| 5 | Consultant | Wahib Medanat Consultant Engineer | Rep No. | 12-10112021 |
| | Contractor | Derar Saraireh & Sons for Engineering & Contracting | Tender No. | (11/2019/USAID/SKEP/3/S) Schools for a Knowledge Economy Project (SKEP) - Phase (3) Package (1, 2) |
| | Site Name | Al Khansa' Basic Mixed School- Al Balqa | Day/ Date | Wed. 10/11/2021 |

SKEP III Home Office Support Site Visit Report

(Figure: 17)

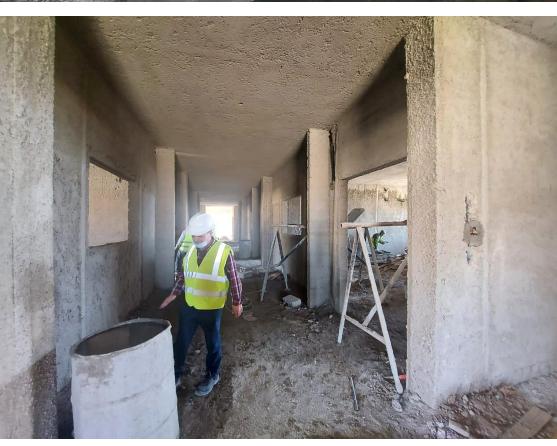
The team observed that a water penetration test has been conducted for the floor of one of the toilets

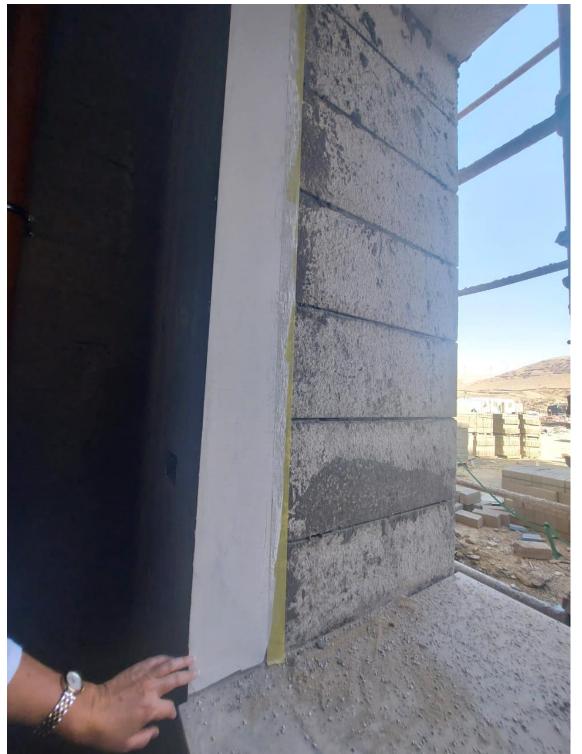
A general check was conducted to insure that the executed works comply with the approved workshop drawings

(Figure: 24 & 25)

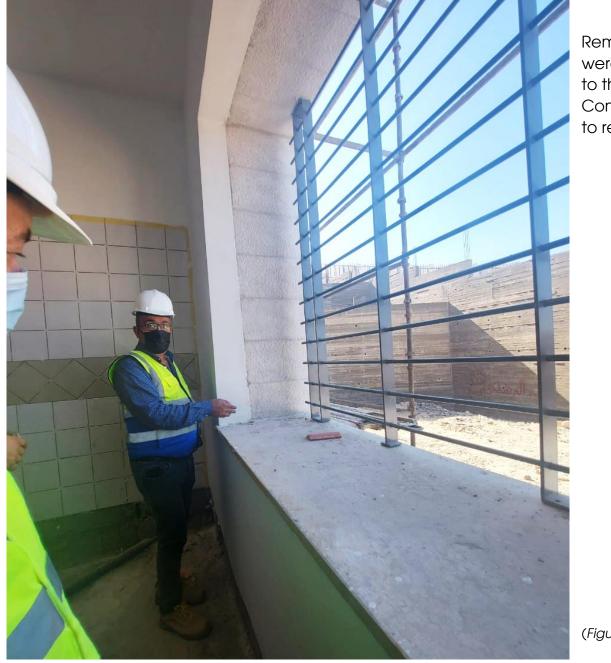
The team observed that the Contractor started with the painting work for window jambs before preparing the plastering to be ready for painting

Remarks were given to the Contractor to rectify
